HEARING DATE: November 22, 2022

TO: Mayor & City Council

SUBJECT: Kingstown
H-2022-0045

Annexation of 8.20 acres of land with an R-8 zoning district; and preliminary plat consisting of 28 building lots and 6 common lots on 8.20 acres of land in the R-8 zoning district for Kingstown Subdivision.

B. Preliminary Plat, Existing Conditions & Phasing Plan (dated: 11/07/2022)

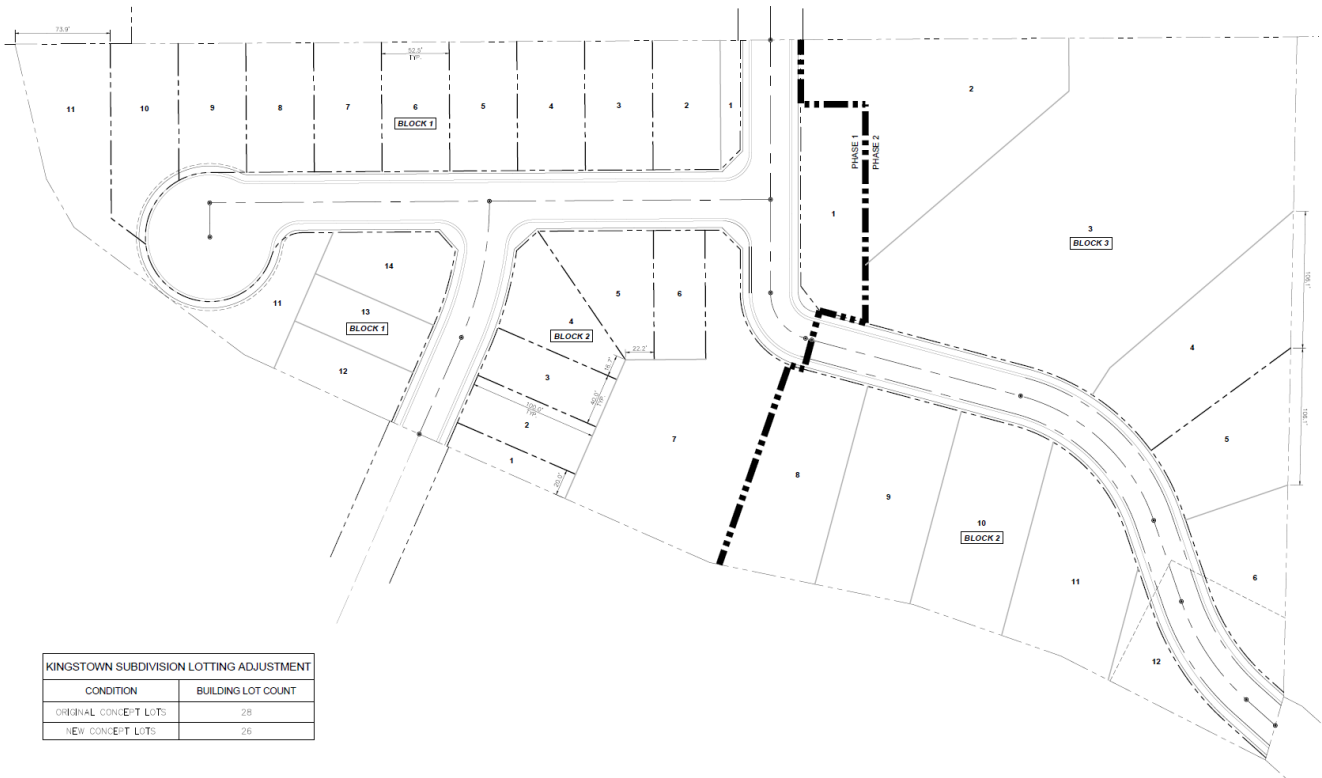
Although the gross density for the overall development at 3.42 units/acre is within and at the low end of the desired density range in the MDR designation, the lot sizes proposed in the first phase along the north boundary are not compatible in size and provide a poor transition to existing lots. The proposed lots in Phase I are mostly 4,000 square feet (or 0.09 acre), while the abutting existing lots in Zebulon Heights and Champion Park subdivisions are 0.25+ acre in size. The transition from proposed to existing homes along the north boundary range from a 2:1 to a 5:1 transition. A better transition in lot sizes should be provided. No buffering or screening is proposed.

The lot sizes proposed along the eastern boundary in Phase II are much larger/wider and range from a 1:1 to 1:4 transition. A better transition in lot sizes should be provided in this area as well. No buffering or screening is proposed.

An open space exhibit was submitted that depicts 1.23 acres (15%) common open space for the development (see Section VIII.E). Three (3) of the six (6) common open space lots (i.e. Lot 6, Block 2 and Lots 1 & 5, Block 3) are open grassy areas of at least 5,000 square feet (s.f.) in area and qualify toward the minimum standards. **Lot 1, Block 1 does not qualify; however, if the sidewalk is detached in this lot and an 8-foot wide landscaped parkway is provided, it would qualify per UDC 11-3G-3B.4.**

Although Lot 15, Block 1 and Lot 11, Block 2 meet most of the *quality* standards for open space areas listed in UDC 11-3G-3A, these areas do not demonstrate integration into the development as a priority and appear to be “leftover” areas that aren’t developable as building lots and don’t meet the *qualified* open space standards listed in UDC [11-3G-3B](#). Lot 15, Block 1 could qualify toward the open space requirement if an additional 70 s.f. is added to the lot in accord with UDC 11-3G-3B.1a. Lot 11, Block 2 could qualify if 715 s.f. is added to the common lot in accord with UDC 11-3G-3B.1a; or, a community garden could be added to the existing lot in accord with UDC 11-3G-3B.1; or, a minimum 20’ x 20’ plaza could be added to the existing lot, including hardscape, seating, lighting in accord with UDC 11-3G-3B.1. The plans should be revised as recommended by Staff to meet the minimum qualified open space standards.

Pathways: The Pathways Master Plan depicts a multi-use pathway across this site connecting from the pathway along N. Conley Ave. at the south boundary to the pathway along Rogue River at the north boundary. **In accord with the Plan, a 10-foot wide multi-use pathway should be provided within a 14-foot wide public pedestrian easement; only a 5-foot wide sidewalk is proposed. Staff recommends the plat is revised to include a minimum 20-foot wide common lot to the south of Lot 1, Block 2 to provide a pathway connection from the existing pathway on the east side of Conley Ave. to the south to the common area on Lot 6, Block 2. This will be safer than running the pathway along the front of the building lots along Conley and Eagle View. Staff further recommends the multi-use pathway be extended through the common area on Lot 1, Block 3 and Lot 2, Block 3 and connect to the existing pathway to the north. The landscape plan should be revised to include this pathway and an easement should be submitted and recorded prior to the City Engineer’s signature on the final plat. Note: The Applicant submitted a revised conceptual plat that includes the 20-foot wide common lot for a pathway as recommended by Staff.**

Per the discussion in Section VI, Staff recommends the Applicant reconfigure the lots along the north boundary in Phase I so that wider and fewer lots are provided in that area; and the lots in Phase II are reconfigured and lots are added so that lots are smaller and narrower for a better transition to existing abutting properties. ~~Conceptual building elevations should also be submitted for the 40-foot wide lots that fit on the lots. The plat, conceptual elevations and other associated plans shall be revised accordingly & submitted at least 15 days prior to the City Council hearing. Conceptual elevations and a draft of the revised plat should be submitted to Staff prior to the Commission hearing demonstrating how these changes would affect the overall density and transition to adjacent properties.~~ A revised draft plat has been submitted that depicts three (3) fewer building lots along the northern boundary and two (2) additional lots along the eastern boundary. The proposed conceptual building elevations should fit on most of the reconfigured lots.

- d. Depict a minimum 20-foot wide common lot along the south side of Lot 1, Block 2 containing a 10-foot wide multi-use pathway connection from Conley Ave. through the common areas on Lot 6, Block 2 and Lot 1, Block 3 to the pathway along the east side of Rogue River Ave. Depict 5-foot wide landscape strips on each side of the pathway planted in accord with the standards listed in UDC [11-3B-12C](#).

- e. Increase the size of Lot 15, Block 1 by 70 square feet to meet the qualified open space standard of 5,000 square feet in UDC 11-3G-3B.1a.
 - f. Lot 11, Block 2 does not meet the qualified open space standards listed in UDC 11-3G-3B – the plans should be revised to comply through one of the following options: 1) add 715 s.f. to the common lot in accord with UDC 11-3G-3B.1a; or, 2) include a community garden in the common lot; or, 3) include minimum 20' x 20' plaza in the common lot, including hardscape, seating, and lighting in accord with UDC 11-3G-3B.1. *If the lot is enlarged, the plat shall also be amended accordingly.*

LOTTING ADJUSTMENT
 September 26, 2022

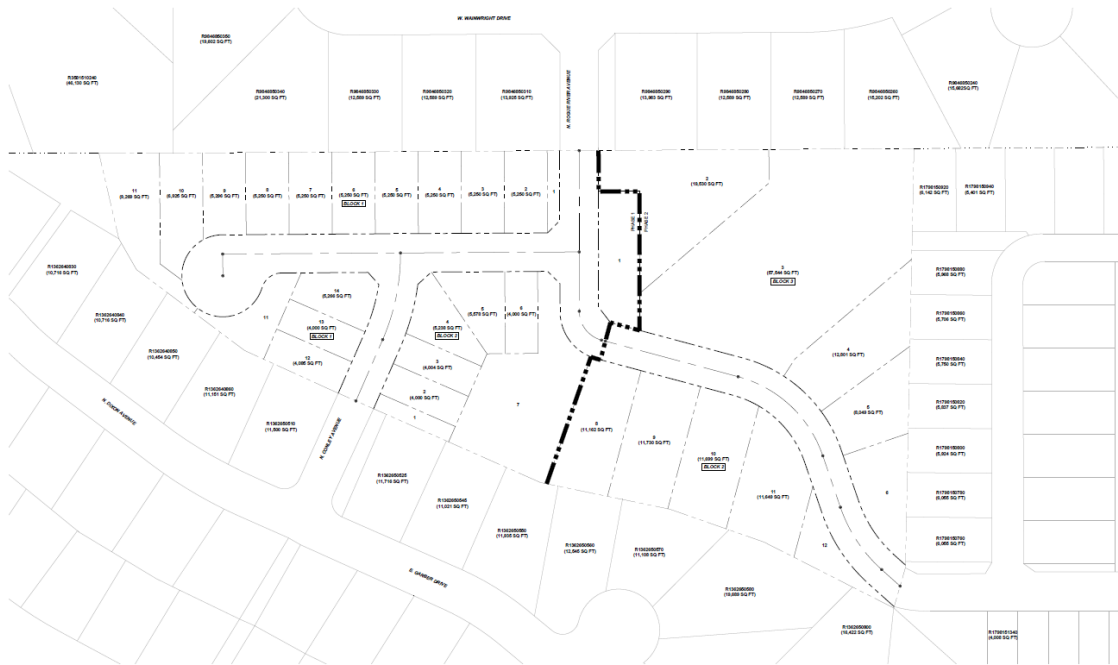
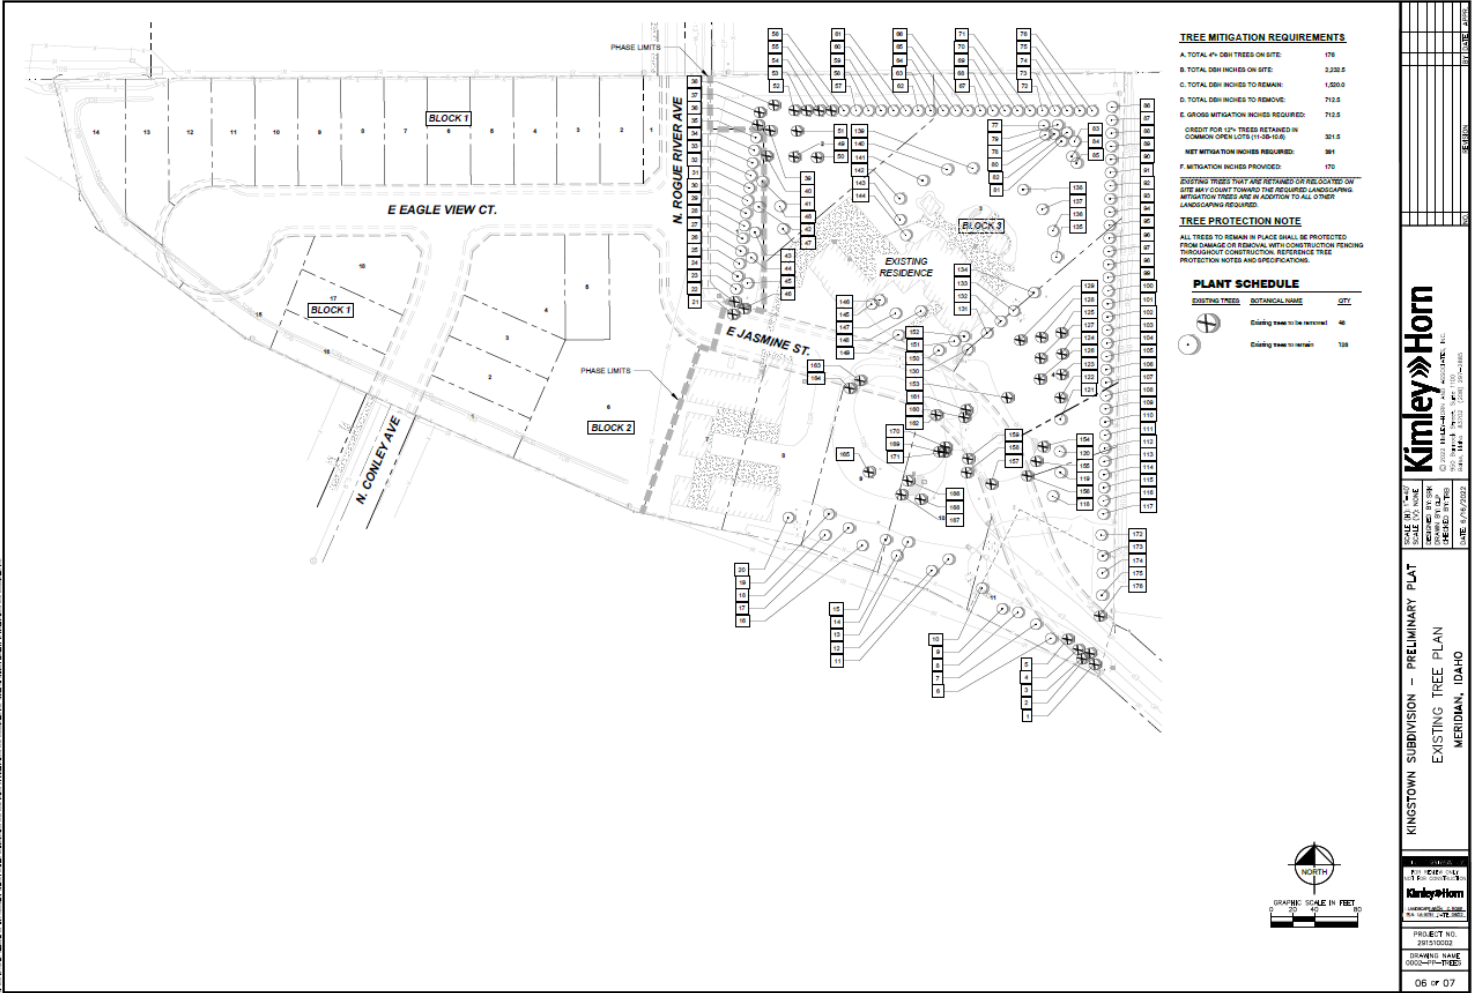
At the recommendation of Staff, a revised conceptual plat was submitted that depicts a reconfiguration of lots within the plat resulting in a reduction in building lots from 28 to 26 and an increase in common lots from 6 to 7 for a gross density of 3.17 units/acre (see Section VIII.B). If the Commission recommends approval of the revised concept plan, an updated plat, landscape plan and open space exhibit should be submitted at least 10 days prior to the Council meeting and the staff report will be updated accordingly.
